U.S. NUCLEAR REGULATORY COMMISSION
STANDARD REVIEW PLAN
OFFICE OF NUCLEAR REACTOR REGULATION

9.2.5 ULTIMATE HEAT SINK

DRAFT Rev. 3 - April 1996

SRP Draft Section 9.2.5
Attachment A - Proposed Changes in Order of Occurrence

3. Figures 1, 2, and 3⁶³ give the residual decay heat release in terms of fractions of full reactor operating power based on a reasonably realistic reactor operating time of 16,000 hours.

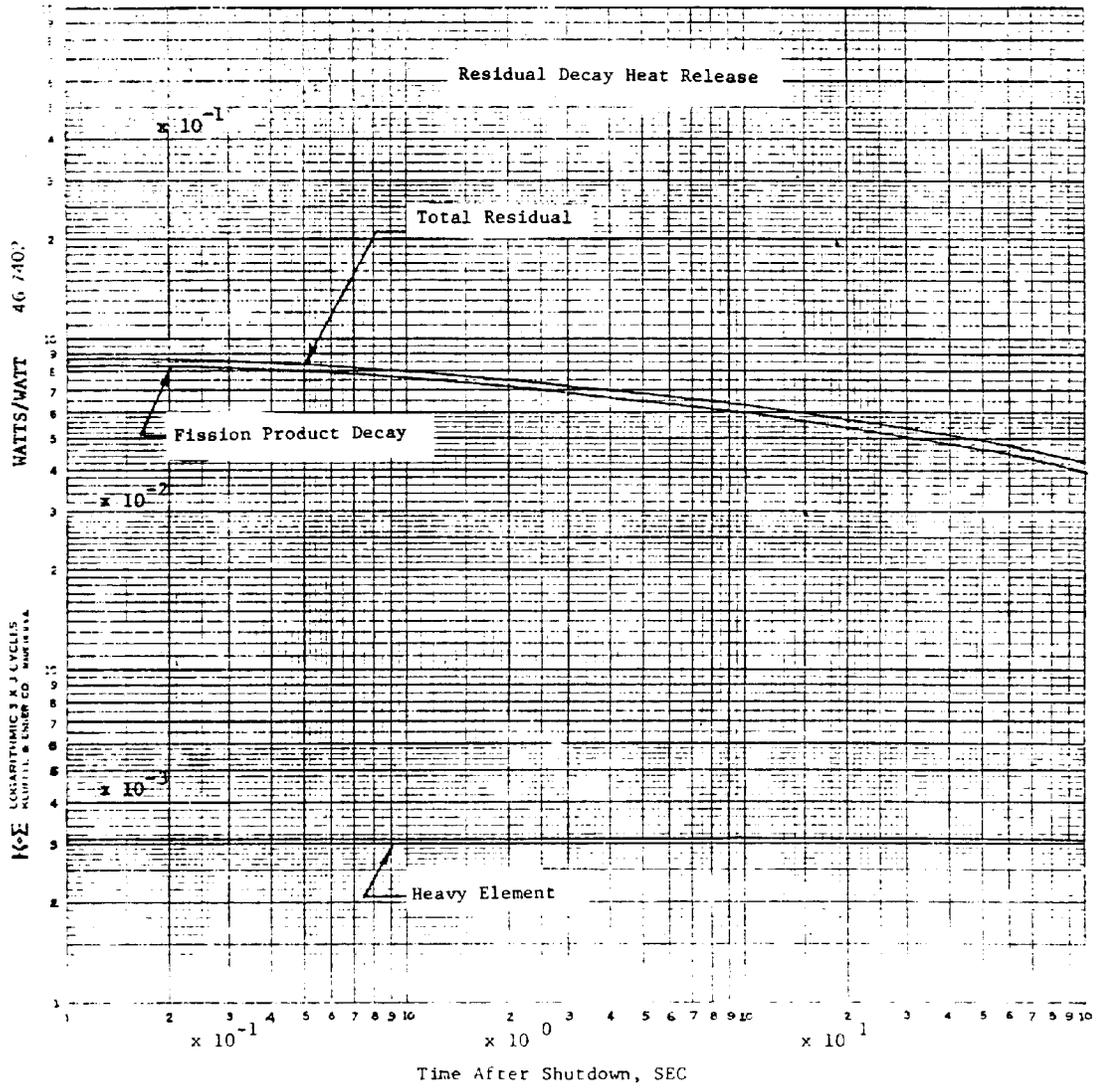
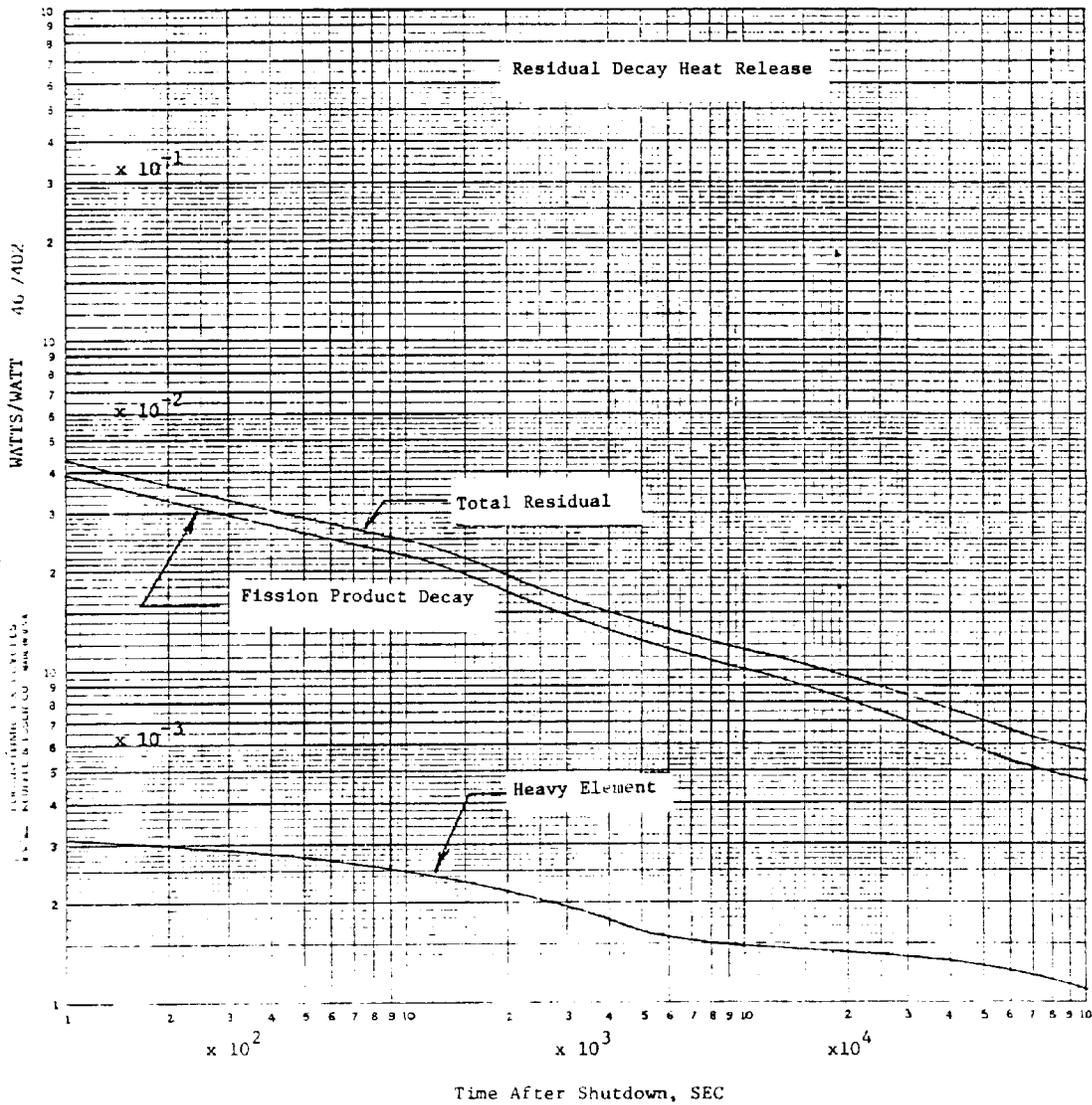
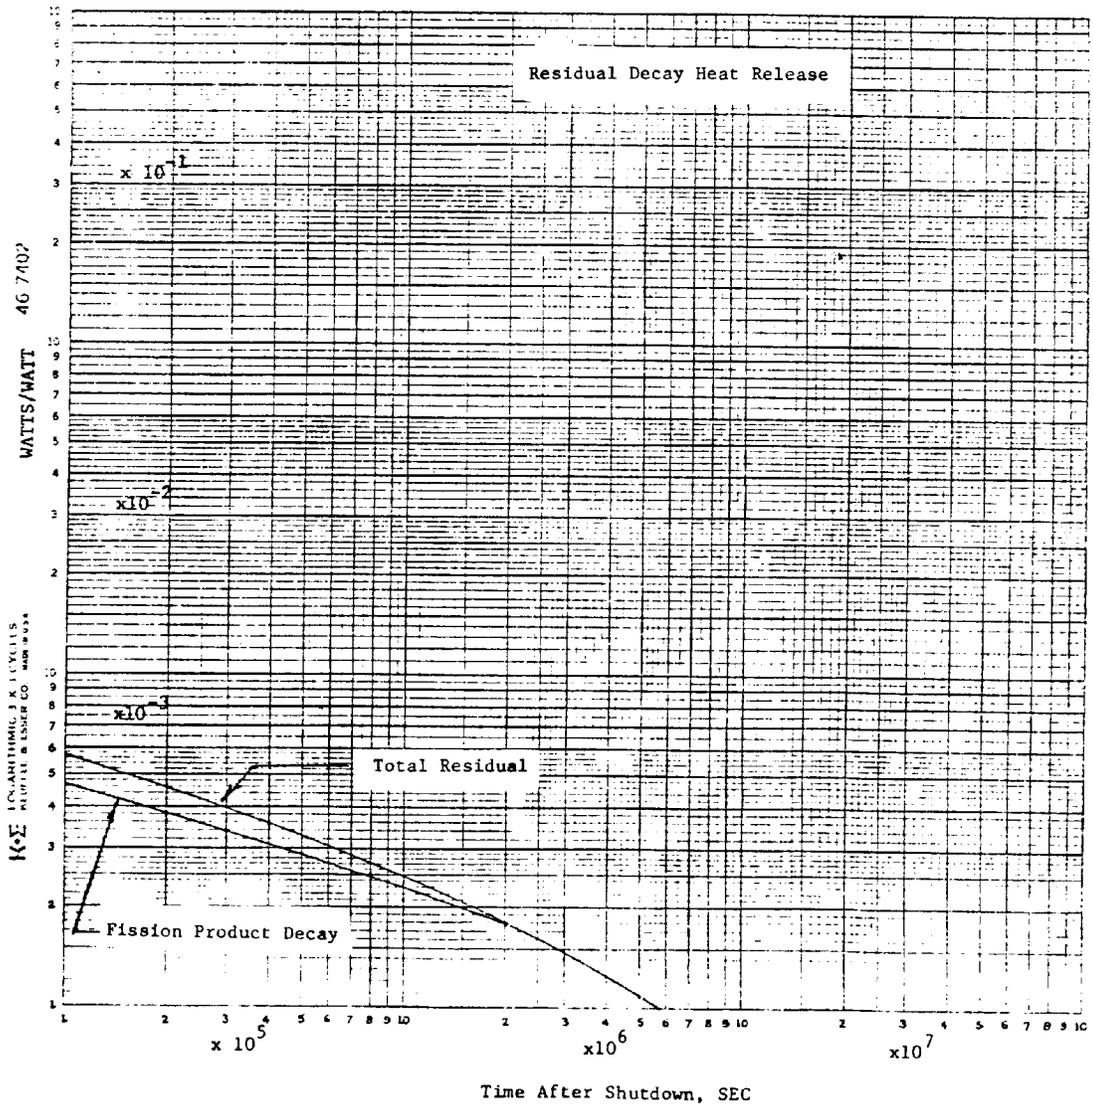
63.	SRP-UDP format item	In-text callouts are provided for Figures 1, 2, and 3. None of the three figures are labeled, however, and all three should be revised to maximize the benefit they provide to reviewers.
